FROM:**Boni•Maddison Architects**

TO:**Bidders****PROJECT:****Unicorn Daycare – Trail, BC Project Number 23-06****TENDER ADDENDUM #2**

This Addendum shall be read in conjunction with and considered as an integral part of the Contract Documents for the above project; revisions supersede the information contained in the original drawings, specifications or previously issued Addendum.

HOR. SCALE	NOT TO SCALE	VERT. SCALE
PROJECT FILE No.	C26001 - 001	
SHEET C8	# IN SET 11	
ISSUE D	REV. 1

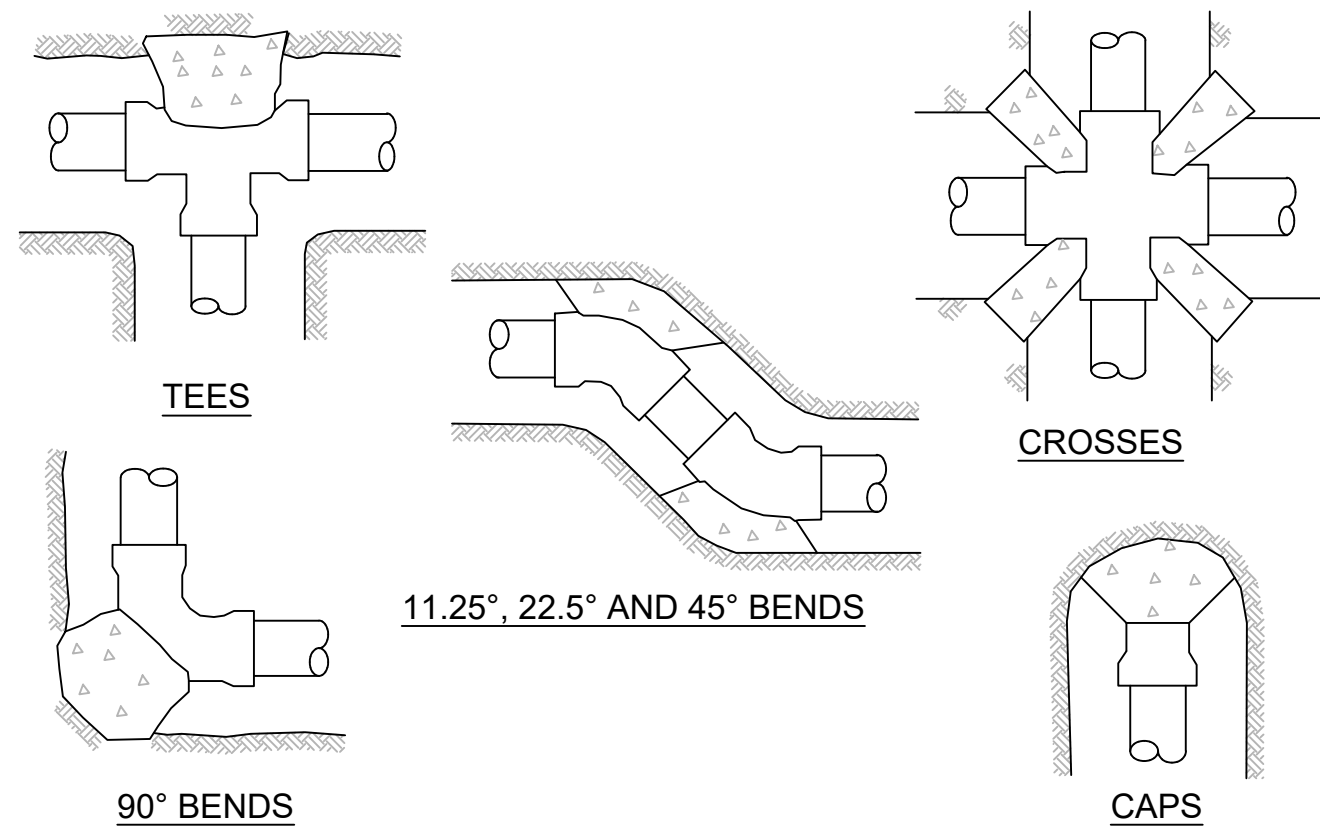
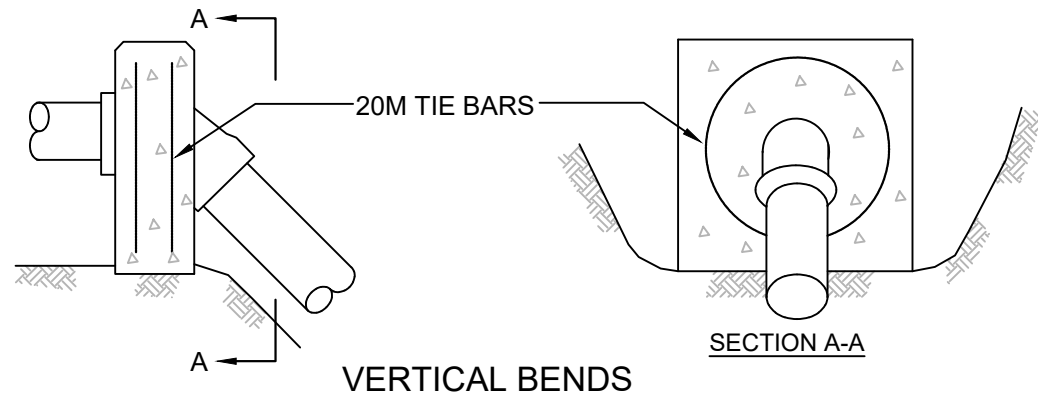
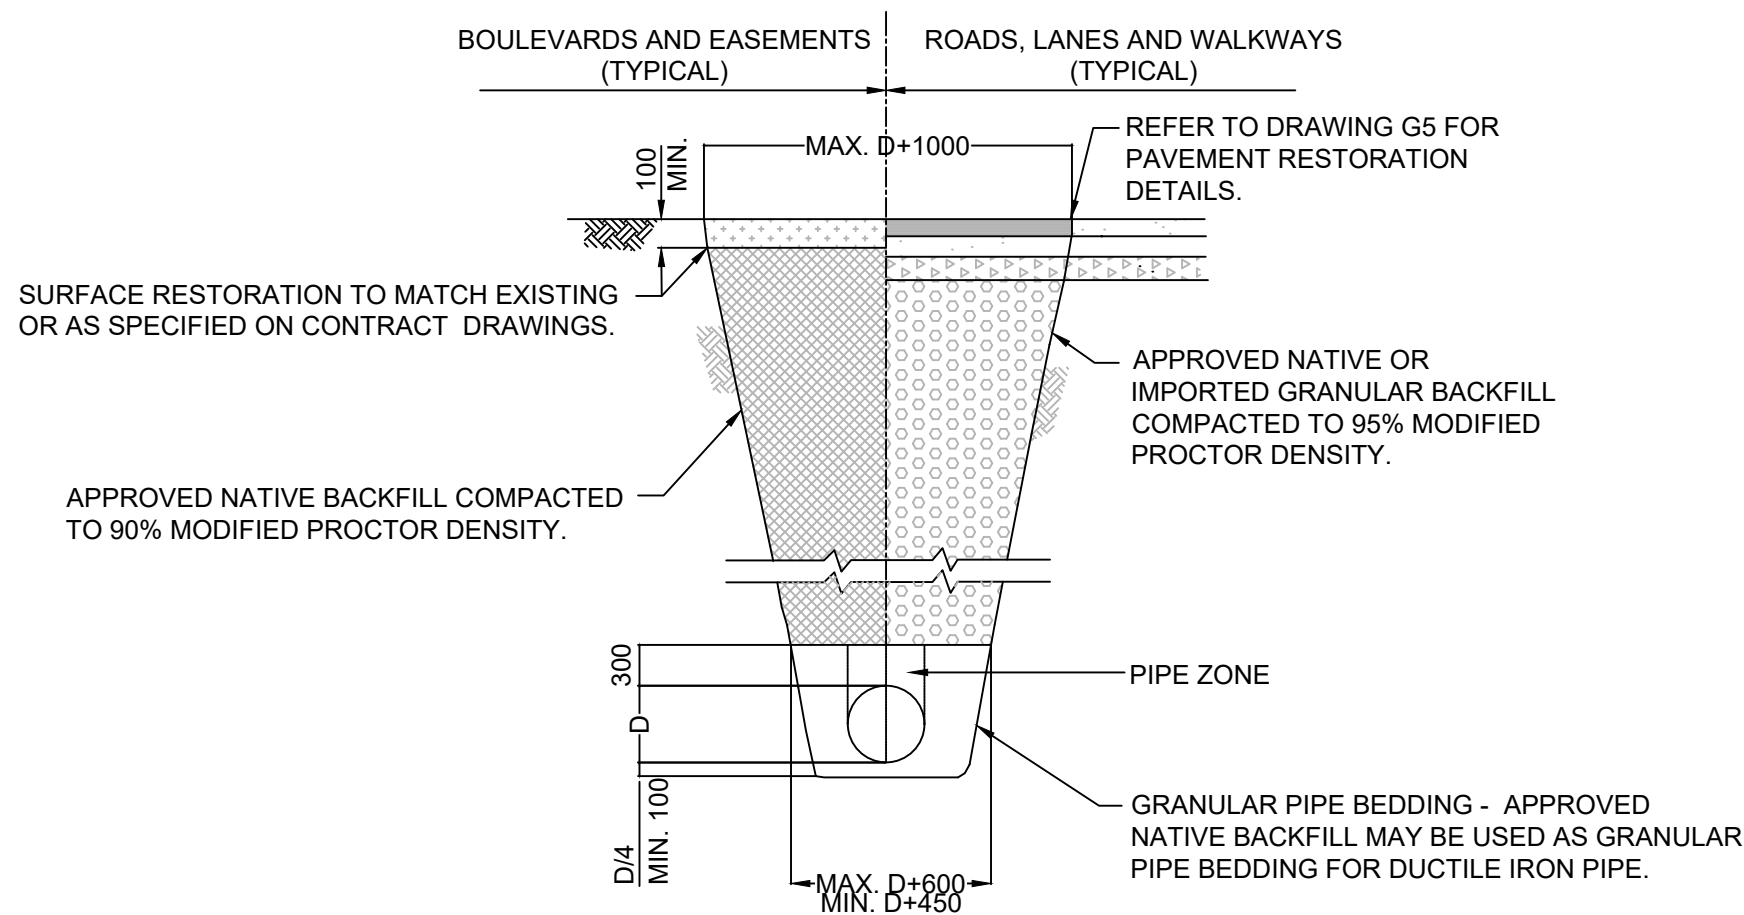
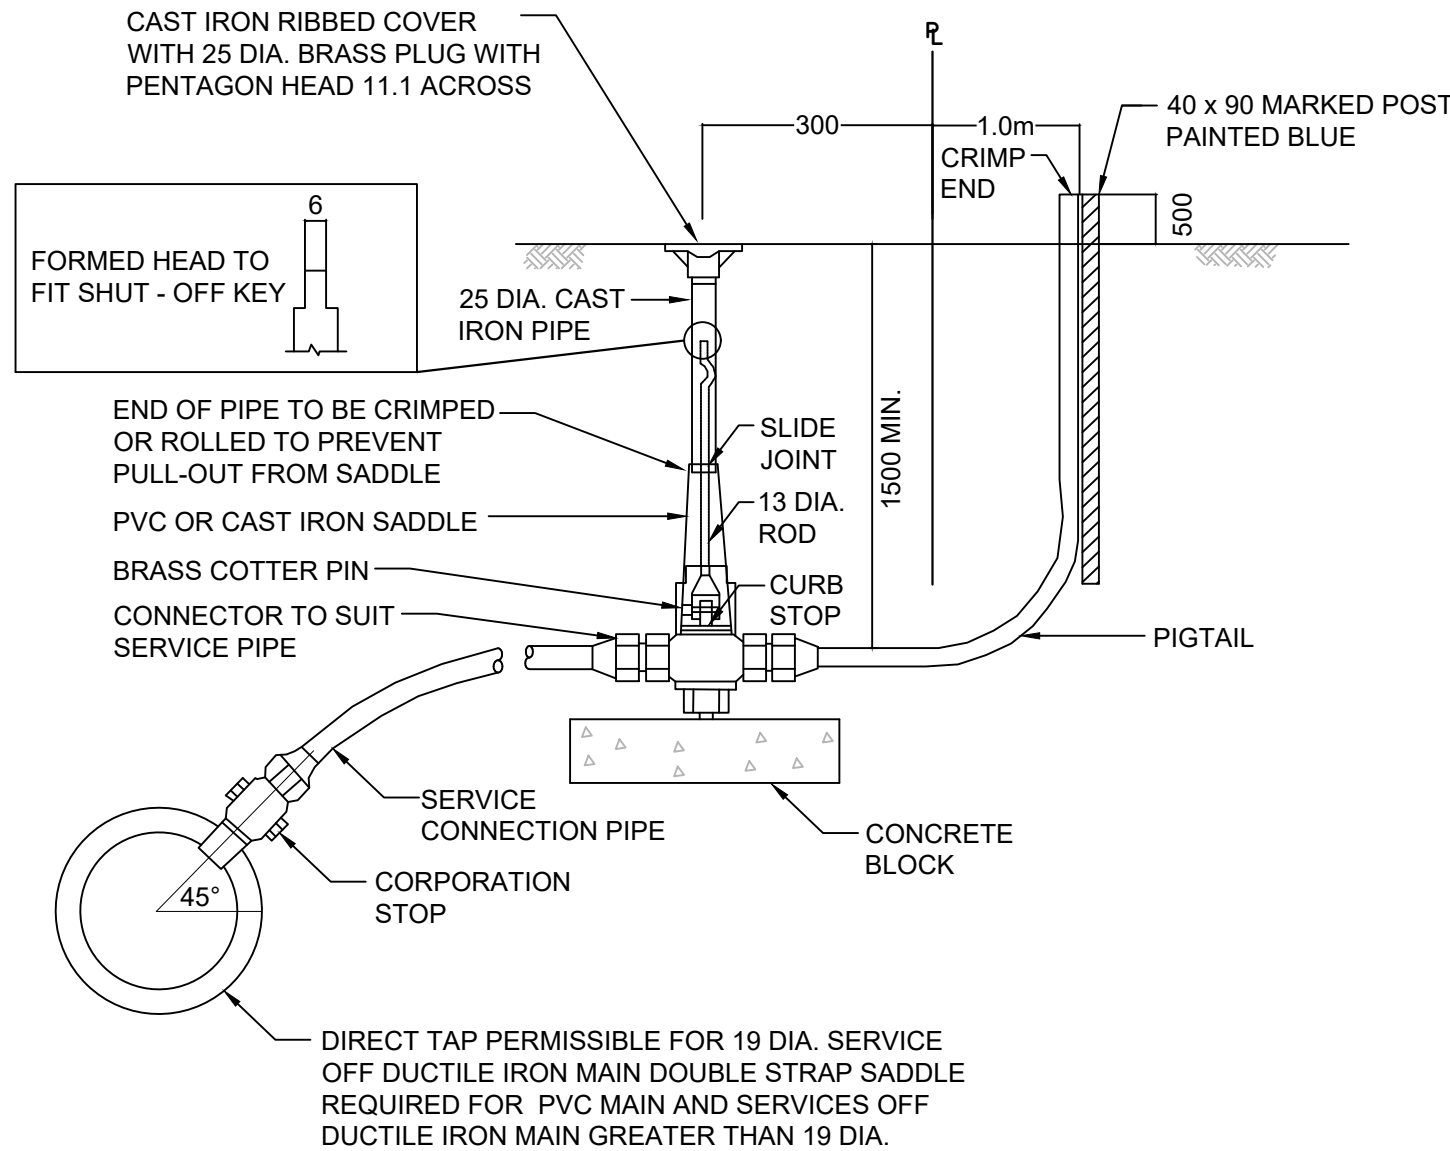
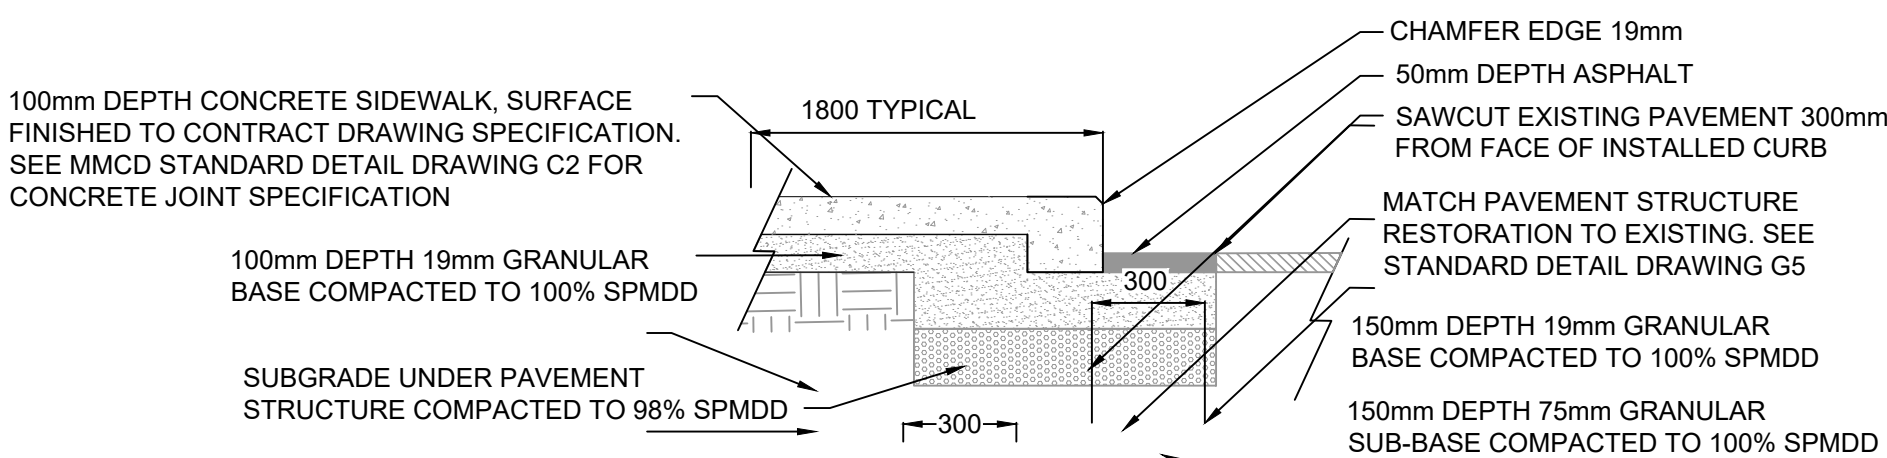
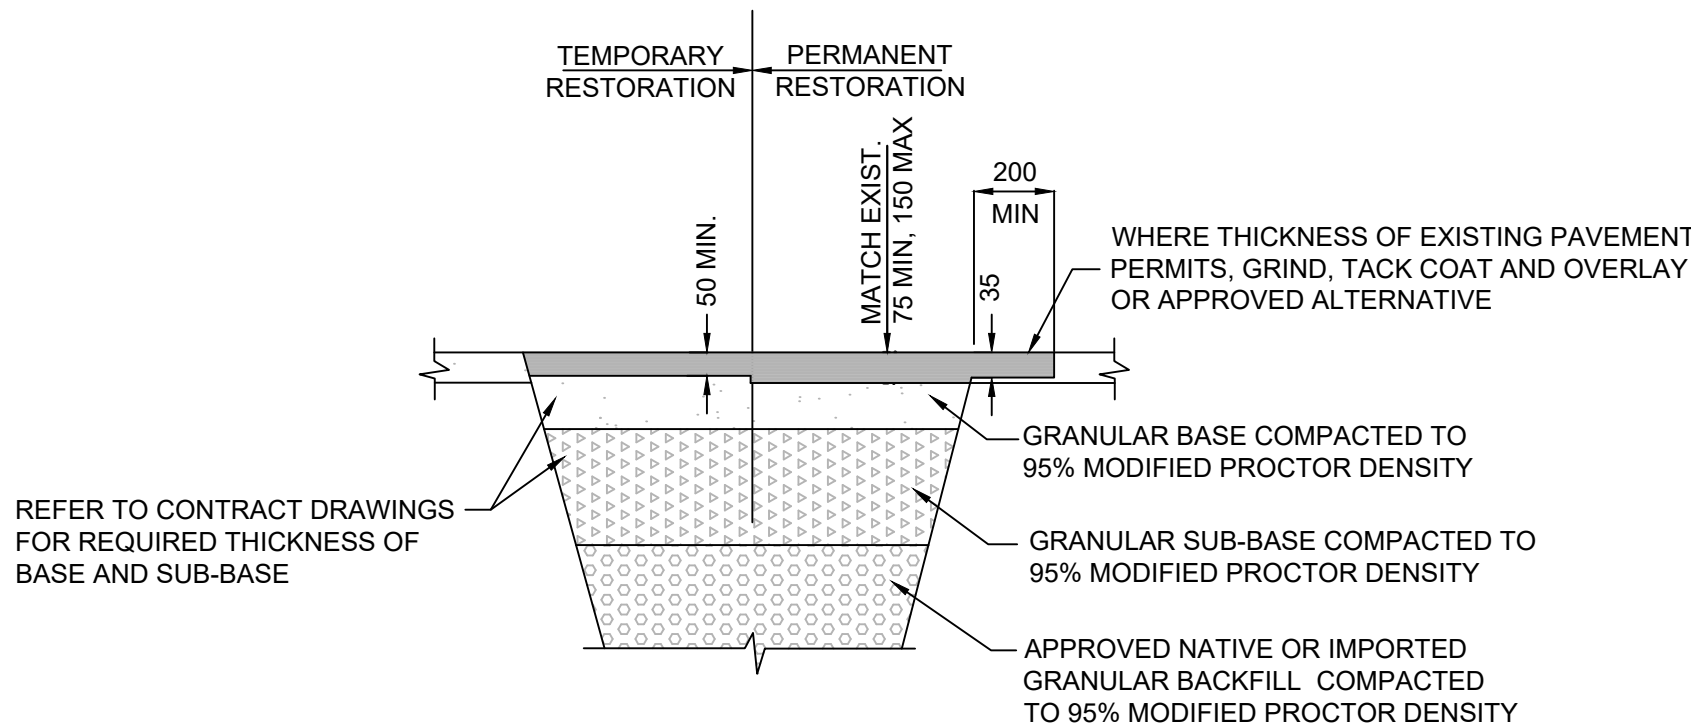
- Landscape details have been added to the site plan for clarification. These are for reference only, in the event of a discrepancy in layout, landscape drawings to take precedence. (Sheet C3)
- Garbage Enclosure added to drawings. (Sheet C3)
- Wheel Chair Let Downs added to either end of the parking. (Sheet C3 (Location) & C8 (Detail))
